711 HUNTER ST, NEWCASTLE

DEVELOPMENT APPLICATION RFI
DESIGN RESPONSE REPORT

19th of May 2023

AMENITY
LOBBY CORRIDOR - STAGE 2

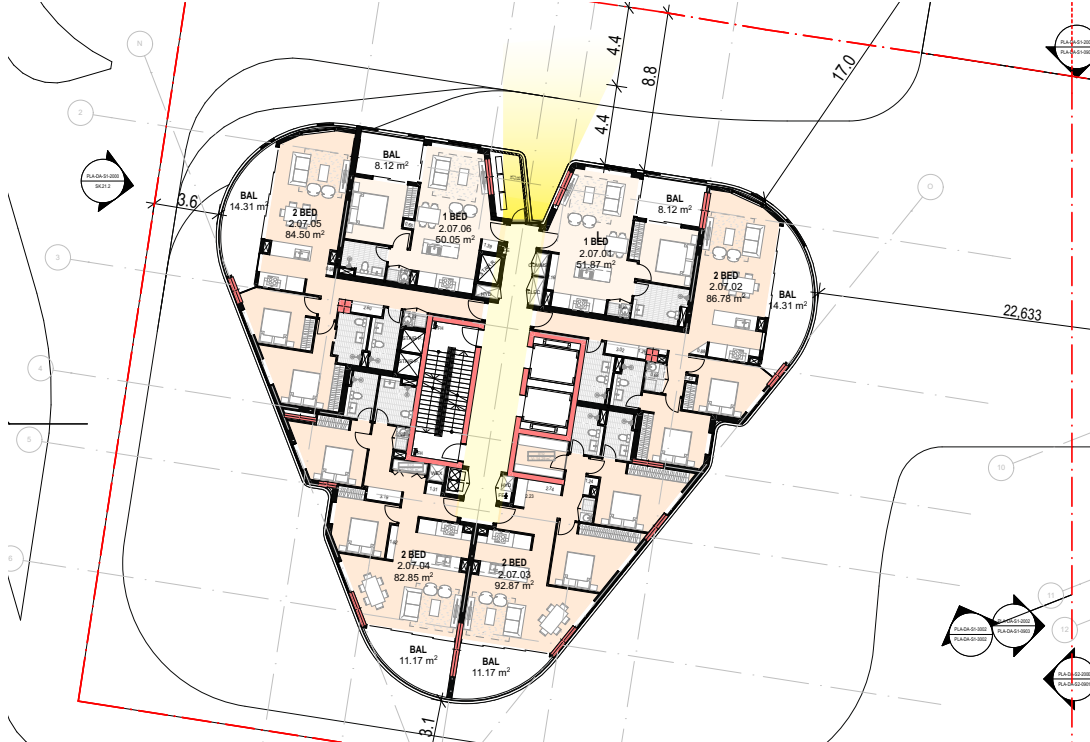
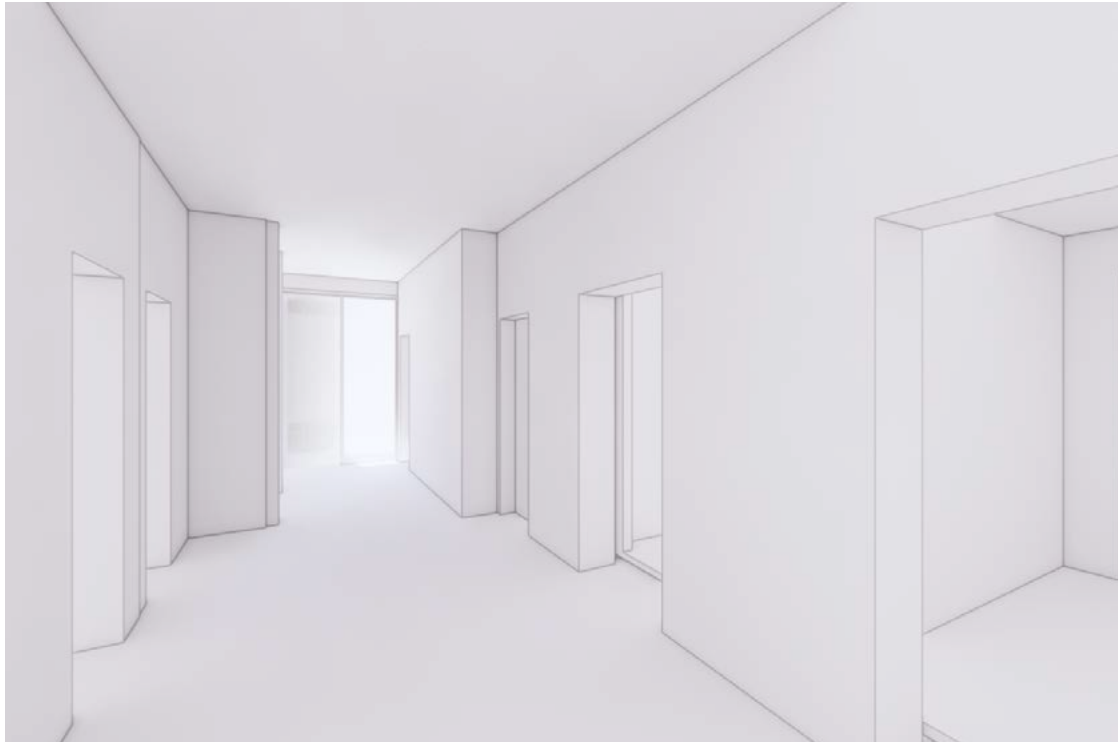
NO	RESPONSE	RESPONSE TO SUBMISSION	SUPPLEMENTARY MATERIAL
4	AMENITY		
	<p>The apartments were generally considered to provide a good level of internal amenity for future residents. Two areas of needed design development for internal/circulation areas relate to the southern tower:</p> <p>1. Internalised studies – A number of “study” alcoves were considered to be unsatisfactory. These are habitable spaces requiring natural daylight and ventilation consistent with ADG requirements (that is, habitable spaces/rooms must not borrow daylight and ventilation from other rooms). This requirement is reinforced by the need of increasing number of people working from home. The Panel further noted this has flow-on implications for increased energy demand for artificial light and ventilation needed for day-to-day functionality over the life time of the development.</p> <p>Exploration of how these spaces can be located on external walls should be pursued. Alternatively, they should be deleted, returning the space to storage or other adjacent habitable spaces. It was also suggested that improved amenity as a bare minimum could be achieved by relocating the adjacent bedroom wardrobe, and aligning the bedroom door and window with the study area so there is an opportunity for some daylight to reach part of the space and so a sightline enabling glimpses to the exterior through windows of the adjacent room.</p> <p>2. The lobby/corridor areas of the southern tower - have reduced access to views and natural ventilation due to the locating of a plant area at the end of the space, which effectively halves the aperture in the western façade. It was recommended that this area either be relocated or rearranged to widen the glazed opening to an extent commensurate to that proposed in the competition design.</p> <p>The Panel noted the proposed solution in turn reduces the proportional modulation of the southern tower massing achieved with the competition design’s expression of massing.</p>	<p>Studies have been removed where access to natural light cannot be achieved. The study nooks are very valuable to apartment purchasers and the interiors team have been working through options with the JV to ensure they make a positive contribution to the apartment spaces. This is documented in the amended DA Architectural Drawings</p> <p>The plant room is the condenser farm to ensure apartment balconies are not burdened by noisy and hot condensers which considerably reduce the usability of private open space. The plant rooms were not considered as part of the competition scheme, they are required to be externally facing for ventilation purposes.</p> <p>Natural light has been achieved into the lift corridor.</p>	<p>Refer to Amenity pages 47-48</p>

The condenser farm is located to prioritise the usability of the private open spaces which significantly increases their quality and value. The incorporation of natural light into the lift corridor adds to the overall quality and ambiance of the building, creating a welcoming atmosphere for residents and visitors.
